MEMORANDUM

DATE: November 26, 2013

SUBJECT: BZA Case 18655 – Application of Bank of America, pursuant to 11 DCMR §§§ 3104.1, 1304.1 and 1325, for a special exception to exceed the 20 percent limit on the amount of the ground floor that may be devoted to banks under subsection 1302.4(a) in order to install an automatic teller machine (ATM) banking center in the HS-R/C-2-A District at premises 1102 H Street, N.E. (Square 981, Lot 806).

SPACE ANALYSIS (A00.00 – Submitted Plan)

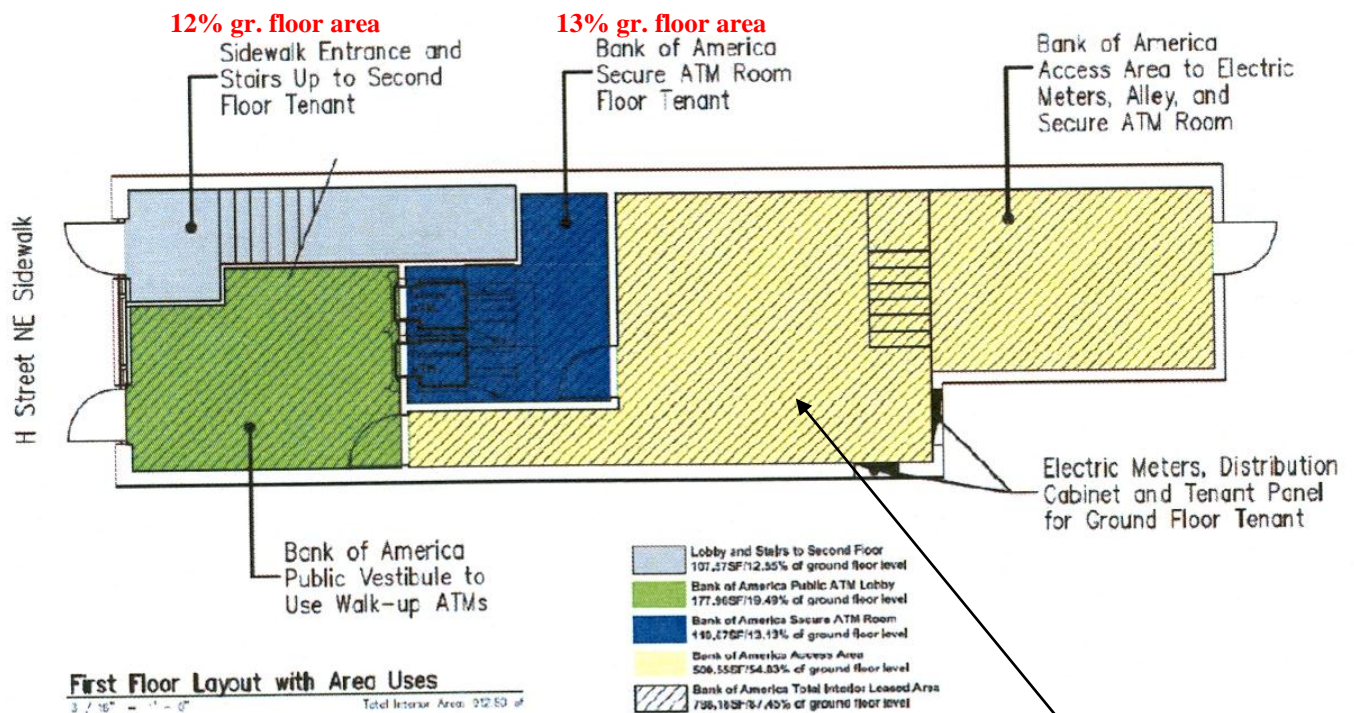
The applicant, Bank of America has proposed the use of the entire area of the ground floor of the commercial row structure at 1102 H St., NE for the installation of its bank ATM. The existing 1,330 square-foot lot is developed with a row structure at 68% lot occupancy with no legal alley access at its rear. The proposed customer lobby would be just under 20% of the first floor area and would be the only public area on the floor to provide customer access to the walk-up ATM's. The ATMs would be installed in a secure area behind the customer lobby, with accessory electronic equipment and electrical cabinets required for the ATMs to function. The facility will be unmanned with infrequent visits by technicians to service the ATMs and its related equipment. This secure area represents about 13% of the ground floor space. (No plumbing would be installed at this level.)

Largely unused space that cannot be leased to other tenant (54% of floor area)
